**ANACOSTIA MUSEUM -  
ADDITION AND RENOVATION  
1901 Fort Place, SE**

Report to the Smithsonian Institution

July 1, 1999

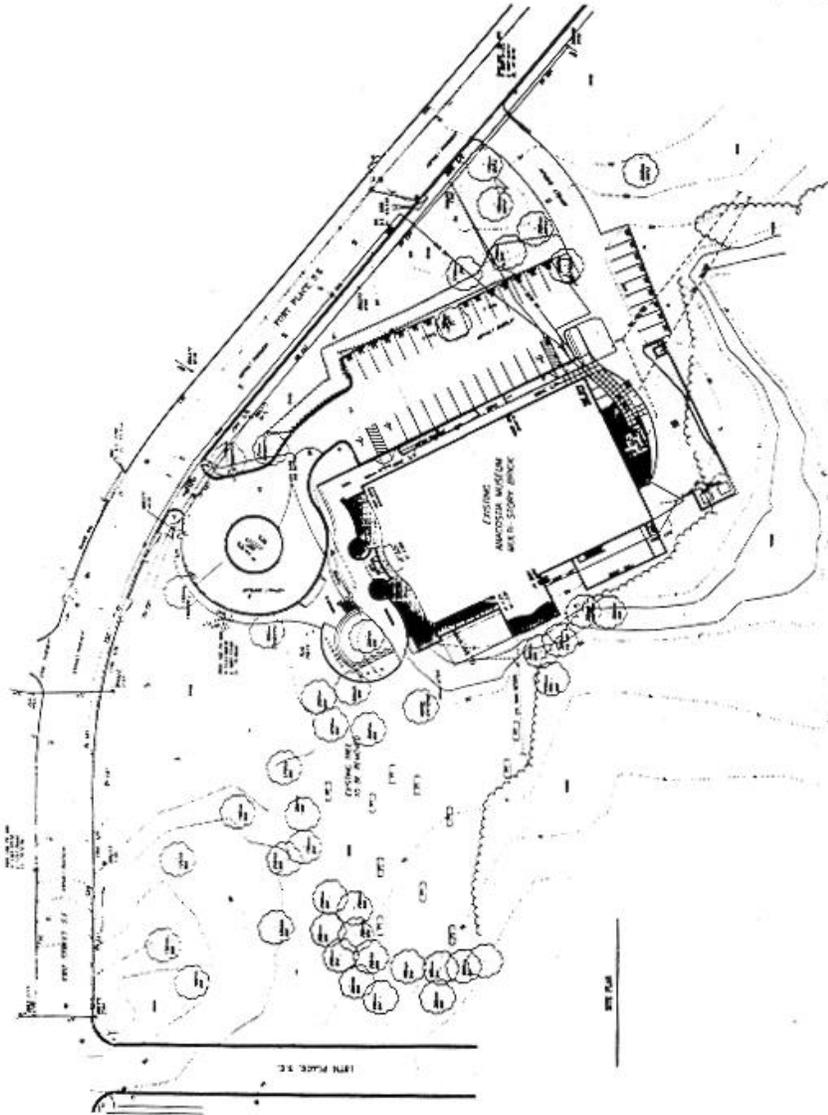
- The scale of the diamond symbol applied to the vertical structures on the new front façade.
- The size of the stairs leading from the bus drop-off circle to the main entrance.
- Termination of the edge of the paved area adjacent to the flagpoles and the curved access ramp located at the front entrance.

Smithsonian staff explained the origin of the diamond symbol and the relevance of its application to the cultural heritage of the museum, and agreed to widen the stairs at the front façade and curve them to express the form of the adjacent retaining wall. They further agreed to curve the edge of the paved area adjacent to the flagpoles to softly terminate at the curved wall of the access ramp. Staff was pleased with the response of the Smithsonian and had no other areas of concern.
